**RE:** File No. 7201 –Fletcher Maynard Academy Boiler Replacement - Addendum No. 1

Addendum No. 1

Fletcher-Maynard Elementary  
Cambridge, Massachusetts

**SKM-1**

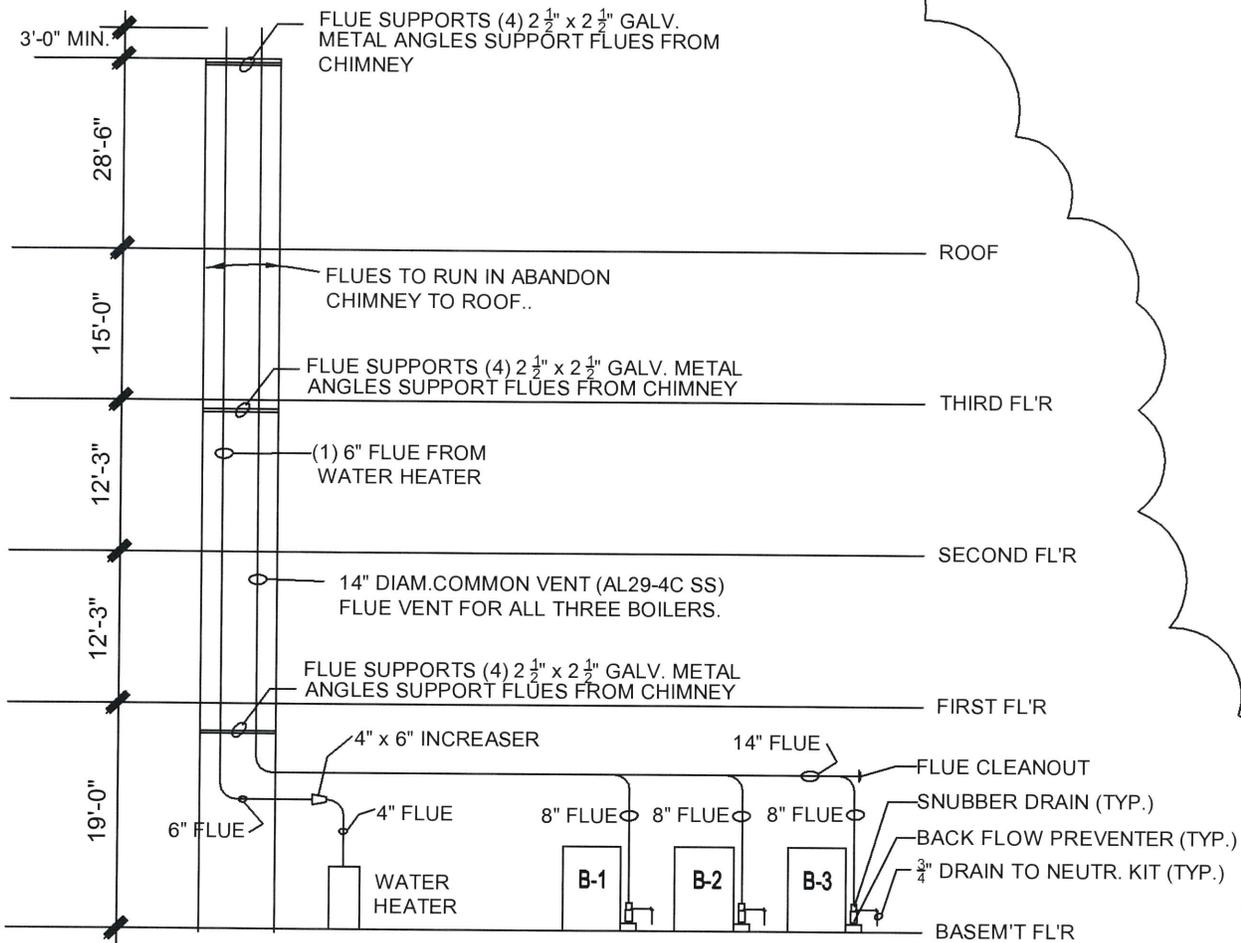
- ITEM #18 Drawing H102, HVAC Schedule and Details, **CHANGE** "UNIT HEATER SCHEDULE" **as per** Sketch SKM-1 attached as part of this addendum.
- ITEM #19 Drawing H102, HVAC Schedule and Details, **CHANGE** "PIPING DETAIL AT END SUCTION PUMP" **as per** Sketch SKM-1, attached as part of this addendum.

# UNIT HEATER SCHEDULE

TAG	MFR	MODEL NO.	BTUH CAPACITY	WATER SIDE		GMP	CFM	REMARKS
				SUP.	RET.			
UH-1	TRANE	20-S2	16,400	140°	120°	3.5	950

## PIPING DETAIL AT END SUCTION PUMP

**SKM-2**

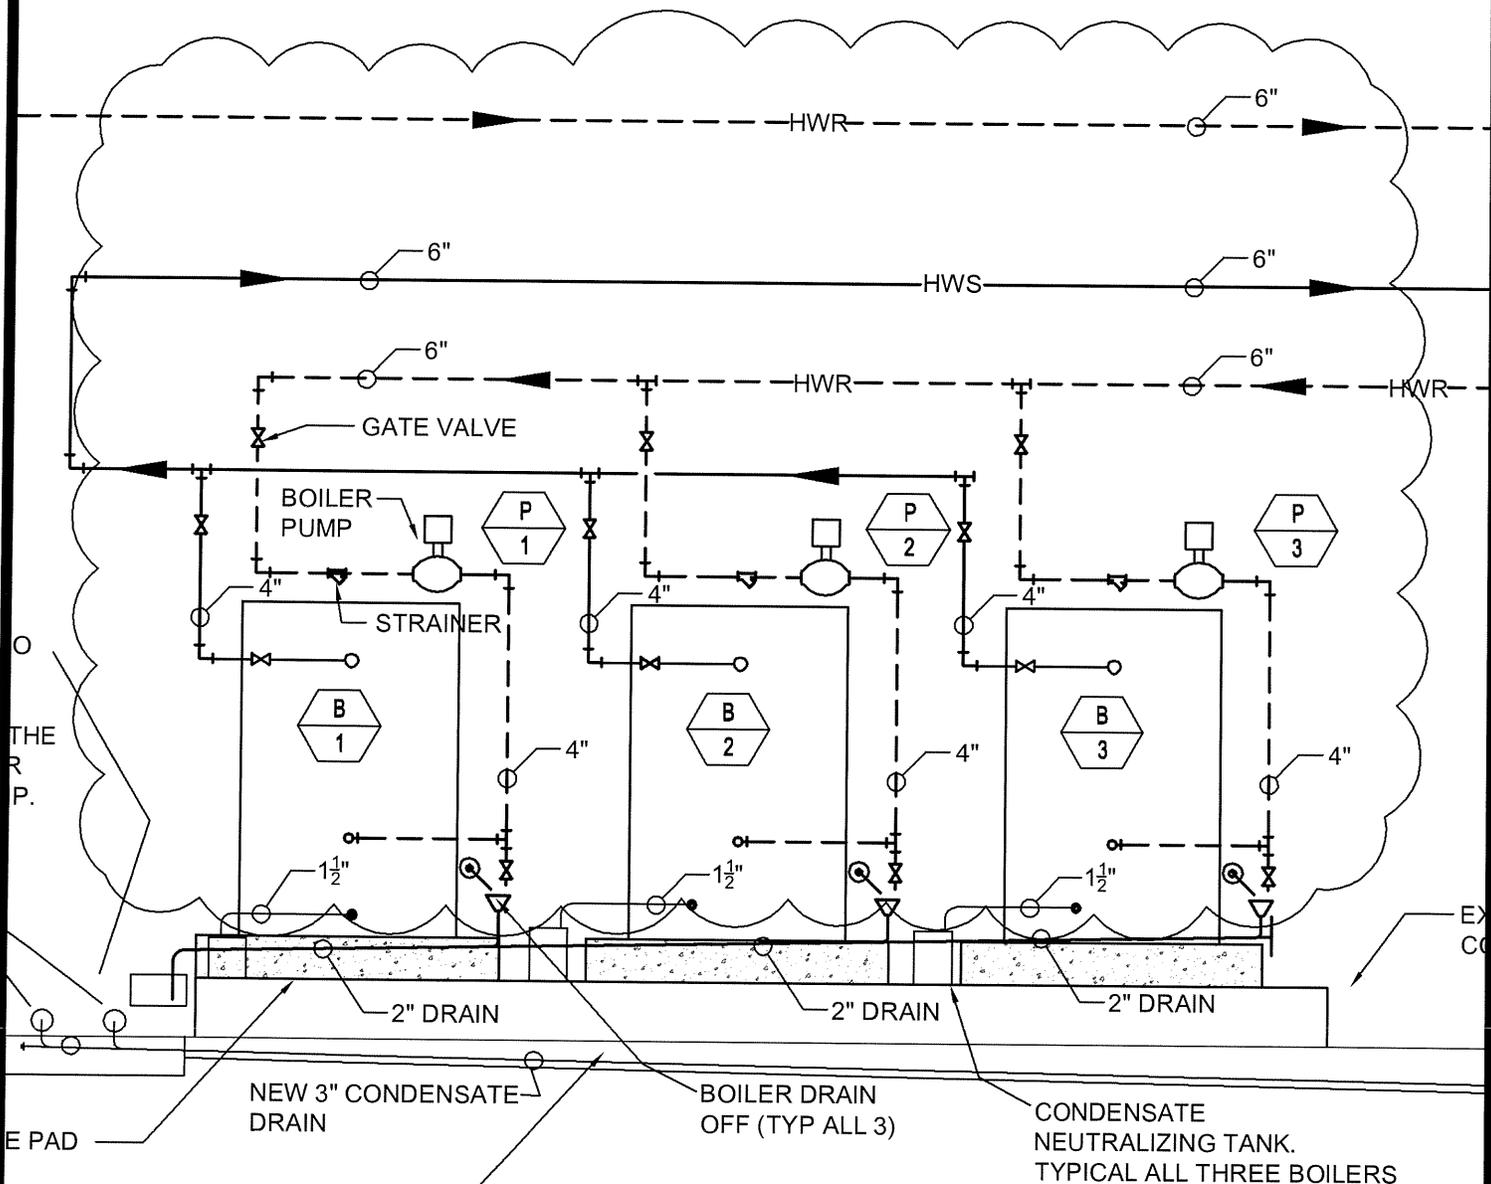
- ITEM #20 Drawing H102 HVAC Schedule and Details, **CHANGE** "BOILER FLUE VENTING SCHEMATIC" **as per** Sketch SKM-2, attached as part of this addendum.

SKETCH NUMBER:  
**SKM-3**

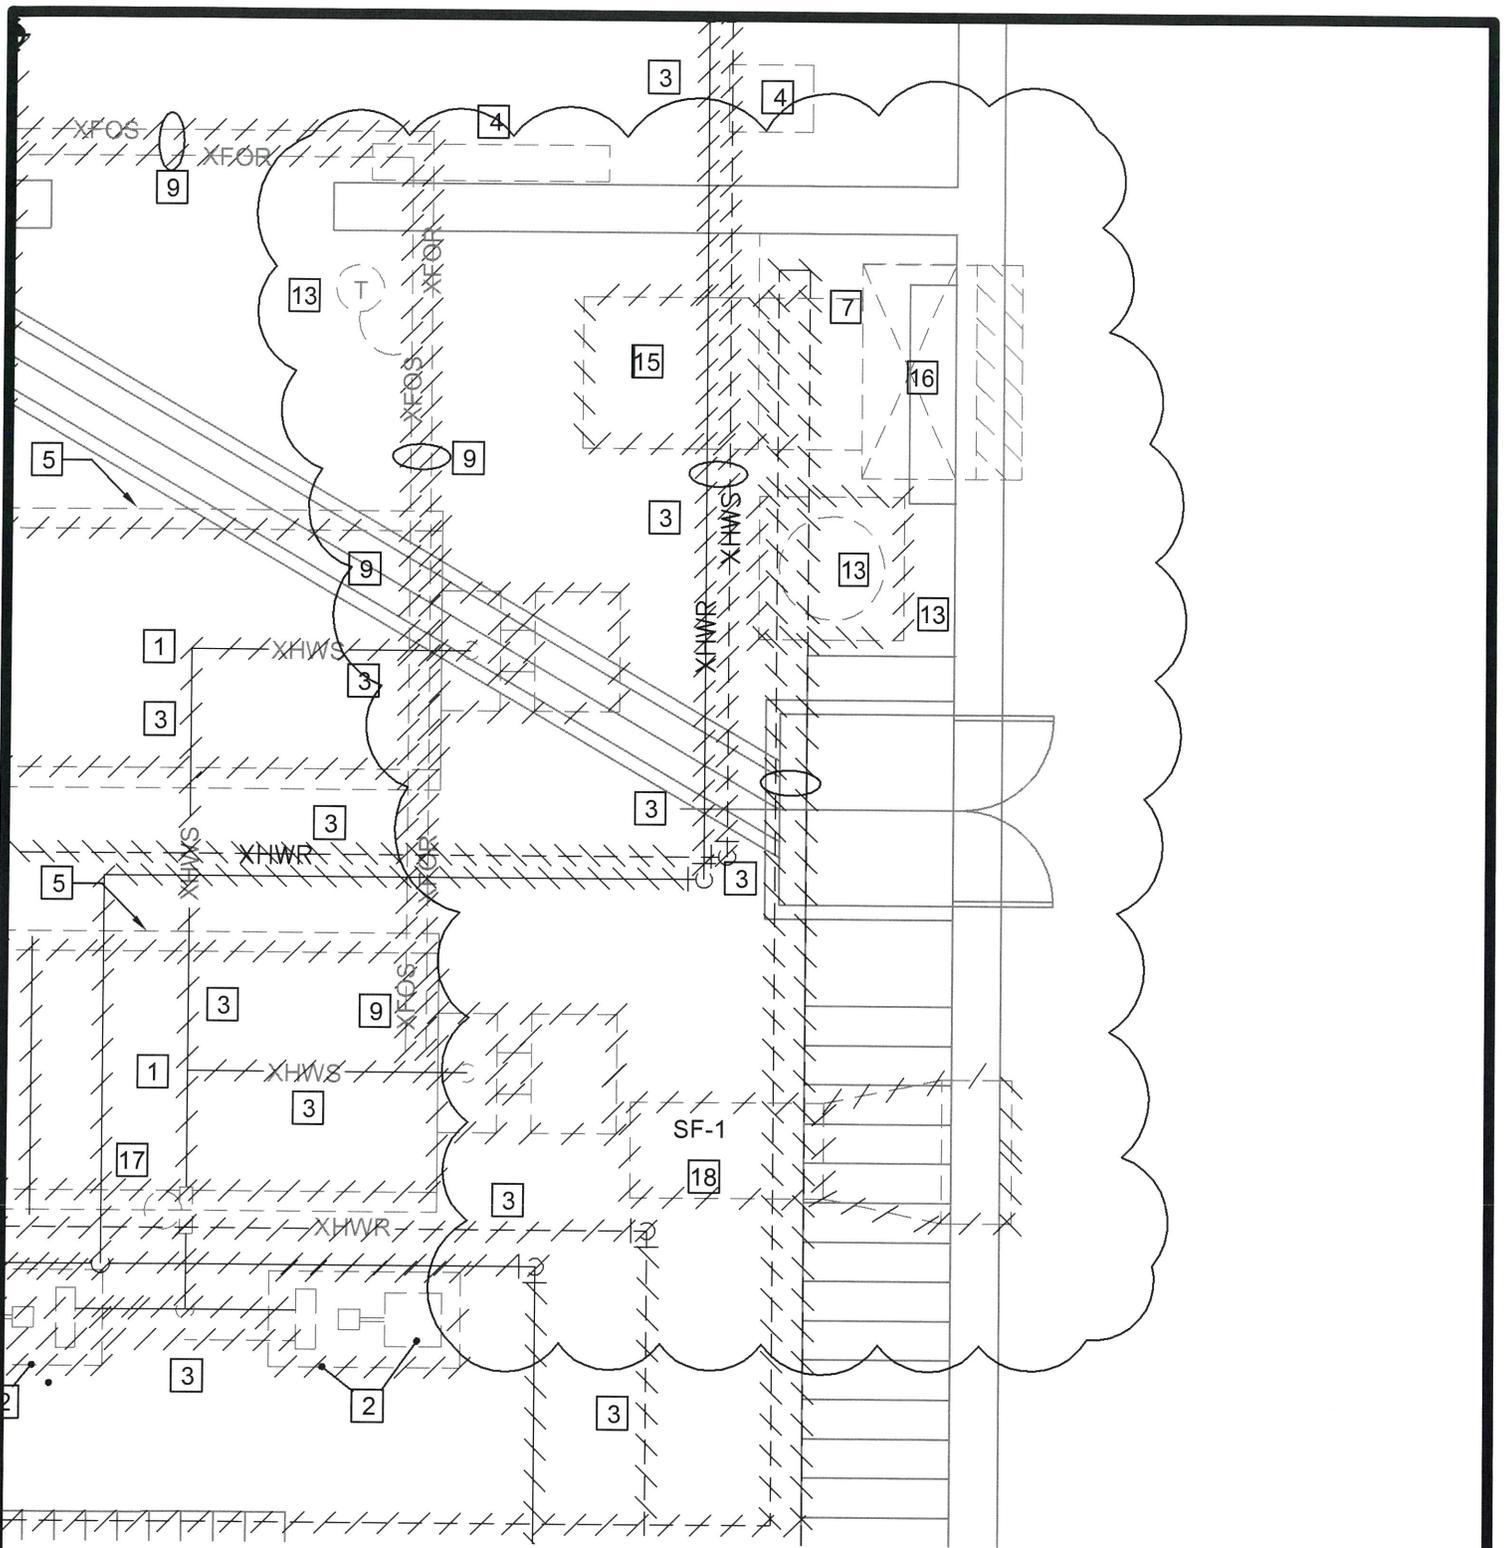
- ITEM #21 Drawing H102 HVAC Schedule and Details, **CHANGE** "BOILER ROOM RISER DIAGRAM" **as per** sketch SKM-3, attached as part of this addendum.
- ITEM #22 Drawing H101 Boiler Room HVAC Plans, **CHANGE** the demolition of the existing fresh air supply to the boiler Room **as per** SKM-4, attached as part of this addendum.

**SKM-5**

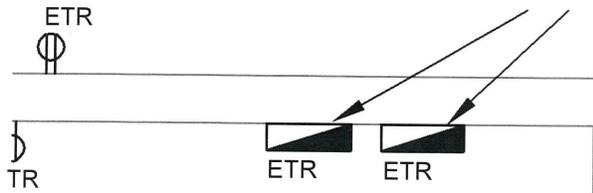
- ITEM #23 Drawing H101 Boiler Room HVAC Plans **ADD** "General Drawing Notes" **as per** sketch SKM-5, attached as part of this addendum.
- ITEM #24 Drawing E101, Boiler Room Electrical Plans, **ADD** on Existing Boiler Room Plan, existing disconnect switch and unit heater to be removed, **as per** Sketch SKE-1 attached as part of this addendum.

GENERAL DRAWING NOTES

- A. FILL ALL SLEEVES SOLID WITH NON-SHRINK MORTAR WHERE PIPING HAS BEEN REMOVED THROUGH EXTERIOR WALL
- B. PROVIDE CIRCUIT SETTERS IN BOILER ROOM ON RETURN LINES (1 1/4", (2) 1 1/2", (2) 4" LEAVING THE BOILER ROOM, FOR BALANCING CONTRACTOR'S USE TO VERIFY FLOW IN EACH SET OF OF DISTRIBUTION RETURN LINES (1 1/4", (2) 1 1/2", (2) 4" LEAVING THE BOILER ROOM.

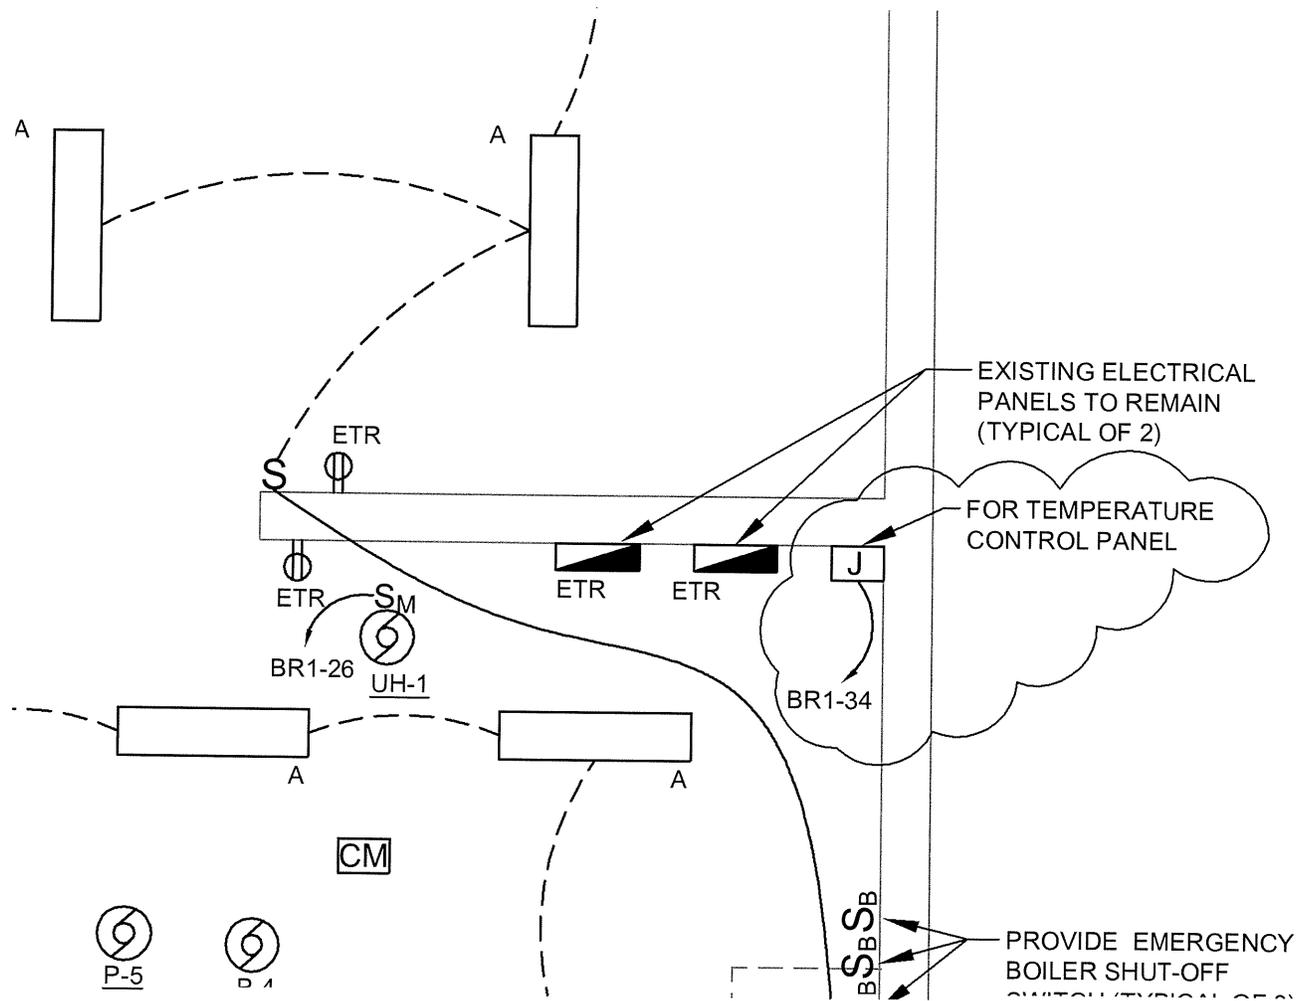
- ITEM #25 Drawing E101, Boiler Room Electrical Plans, **CHANGE** on New Boiler Room Plan, motor being identified as existing recir pump to existing condensate sump pump, **as per** Sketch SKE-2 attached as part of this addendum.

- ITEM #26 Drawing E101, Boiler Room Electrical Plans, **MODIFY** on New Boiler Room Plan, note for CO detectors, **as per** Sketch SKE-2 attached as part of this addendum.

PROVIDE CARBON MONOXIDE DETECTOR, WIRE TO LOCAL FIRE ALARM INITIATION CIRCUIT, DETECTOR SHALL BE OF SAME MANUFACTURER AS BUILDING FIRE ALARM SYSTEM. WIRE TO POINT IN BMS PANEL, COORDINATE WITH HVAC CONTRACTOR (TYPICAL OF 2)

**SKE-3**

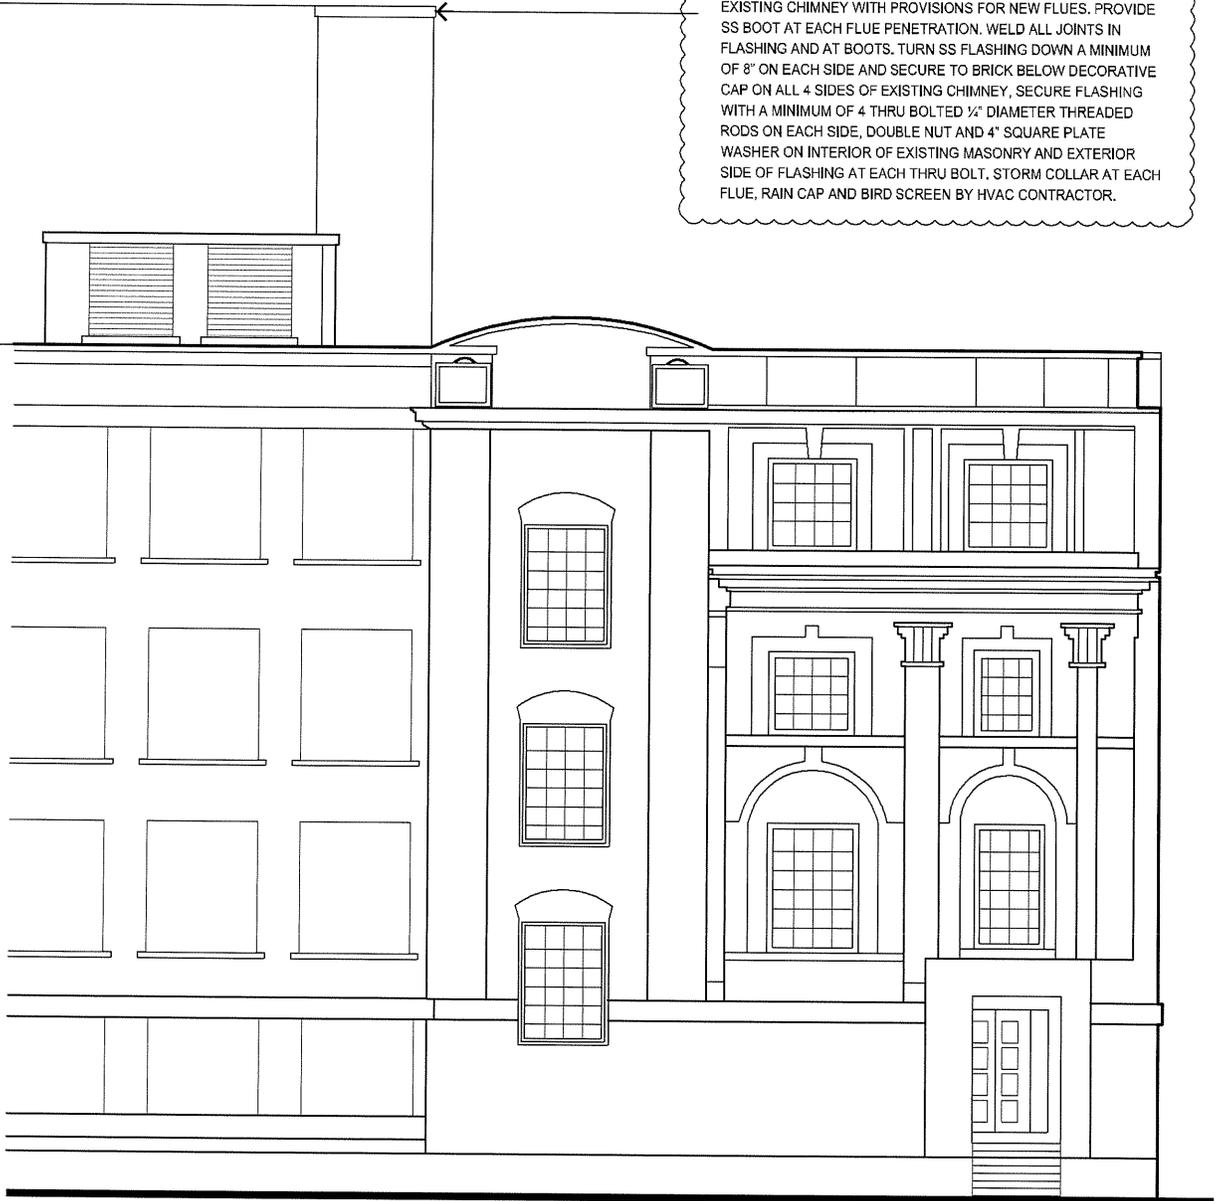
ITEM #27 Drawing E101, Boiler Room Electrical Plans, **ADD** on New Boiler Room Plan, junction box with circuit for temperature control panel, **as per** Sketch SKE-3 attached as part of this addendum.
